CHECKLIST Site Plan / Project Plan Review

Plan # 8-20060310 Name: Montgomery Industrial Park
 Zone: T-1/Overby ^{US 29} Tract Area: 1.69 acres Proposed Use: hotel
 Number of Units: 104 rooms Square Footage: 67,850
 Development Method: 59-D.3 Other: _____

SUBJECT: Stormwater Management Concept Plan/100-Year Floodplain Review
Site Plan # 820060310, Montgomery Industrial Park
Project Plan #
Preliminary Plan # 1-97038, DPS File # 218278
Subdivision Review Meeting of April 10, 2006

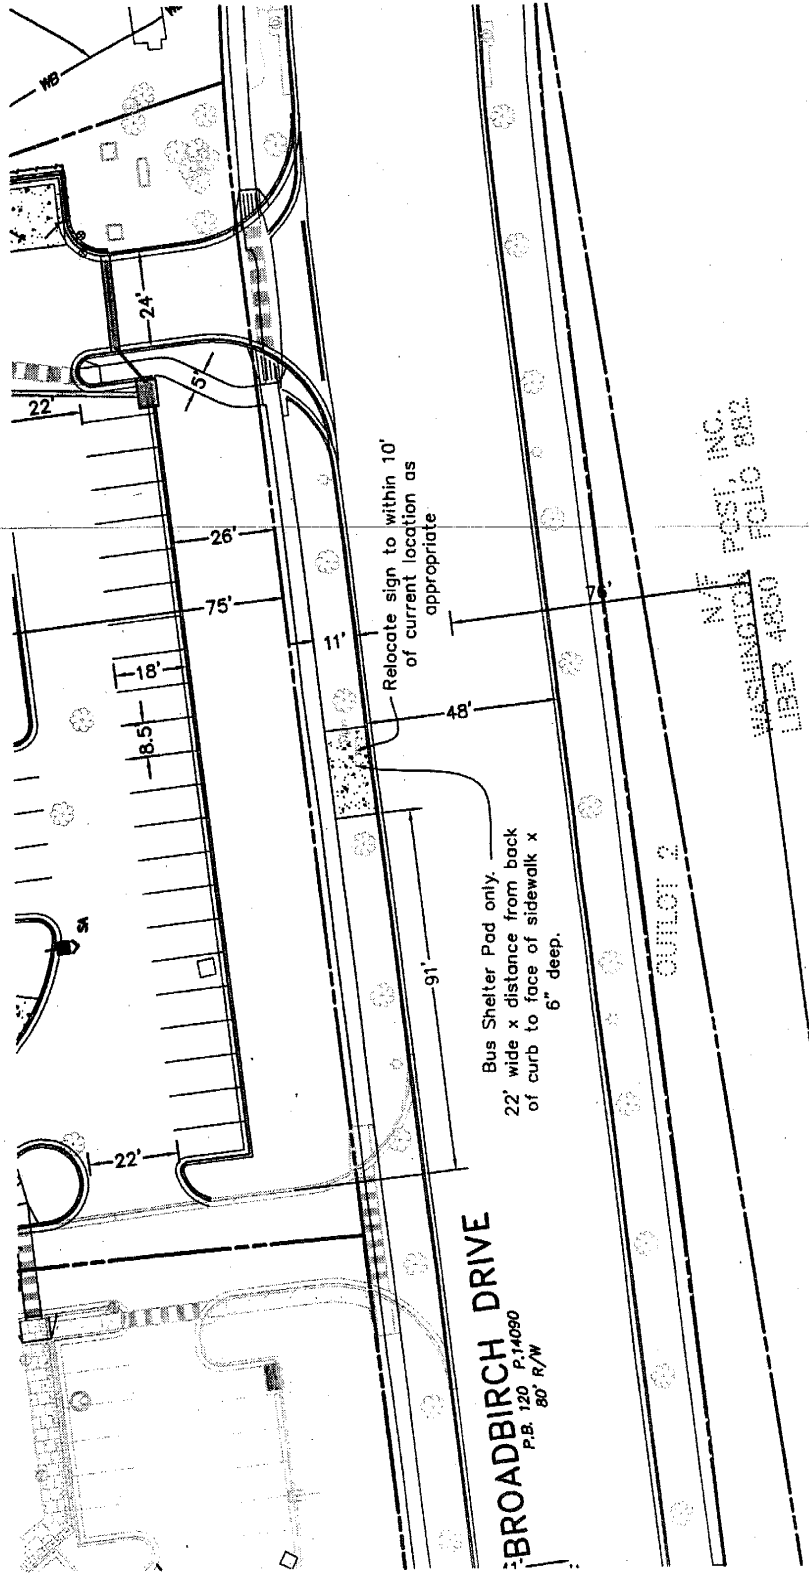
Is this location Ok? Please let Piera and me know. Thanks.

Relocate sign to within 10'
 of current location as
 appropriate

Bus Shelter Pad only.
 22' wide x distance from back
 of curb to face of sidewalk x
 6" deep.

This location looks good for a future bus shelter installation by our ad shelter company. Thanks.
